# SERVICE INFO

## New tensioner pulley kit/set with engine mount for Chevrolet/Opel/Vauxhall 1.7-l diesel engines

<b>Vehicle manufacturers:</b>	Chevrolet, Opel, Vauxhall
<b>Models:</b>	
<b>Chevrolet:</b>	Astra, Corsa
<b>Opel:</b>	Astra G, Combo, Corsa B, Corsa C, Meriva
<b>Vauxhall:</b>	Astra Mk IV, Combo, Corsa Mk II, Meriva
<b>Engines:</b>	1.7 Di, 1.7 DTi, 1.7 CDTi
<b>Part No.:</b>	530 0492 10 (kit) 530 0492 09 (set)

**Image 1:** Replaced tensioner pulley 531 0166 20 (1) and its successor 531 0819 10 (2)

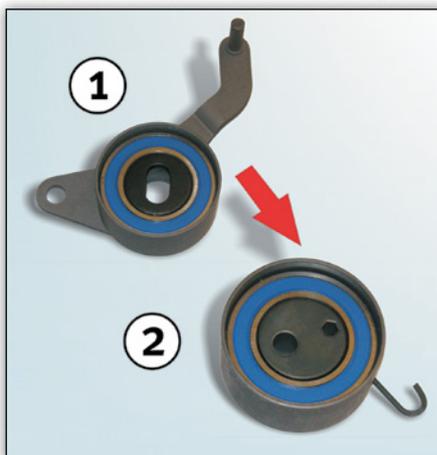
The vehicle manufacturers named above intend to complete a product replacement when the tensioner pulley is replaced. The existing tensioner pulley with part number 531 0166 20 will be replaced by the tensioner pulley with part number 531 0819 10 (see Image 1).

**Image 2:** Package contents: 530 0492 10

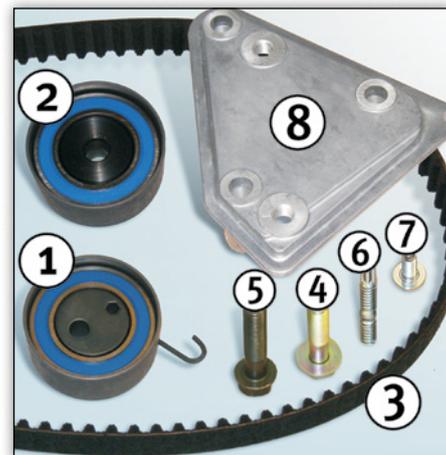
As part of this conversion, models up to engine number 328704 must be fitted with a new engine mount (see Image 2, Item 8). For this reason, Schaeffler Automotive Aftermarket provides the tensioner pulley

kit 530 0492 10 and tensioner pulley set 530 0492 09 for the conversion process. Both products include a new engine mount.

From engine number 328705, the engine mount (OE No. 684051) is already fitted. Tensioner pulley kit 530 0494 10 and tensioner pulley set 530 0494 09 are offered without engine mount for vehicles manufactured from this point.
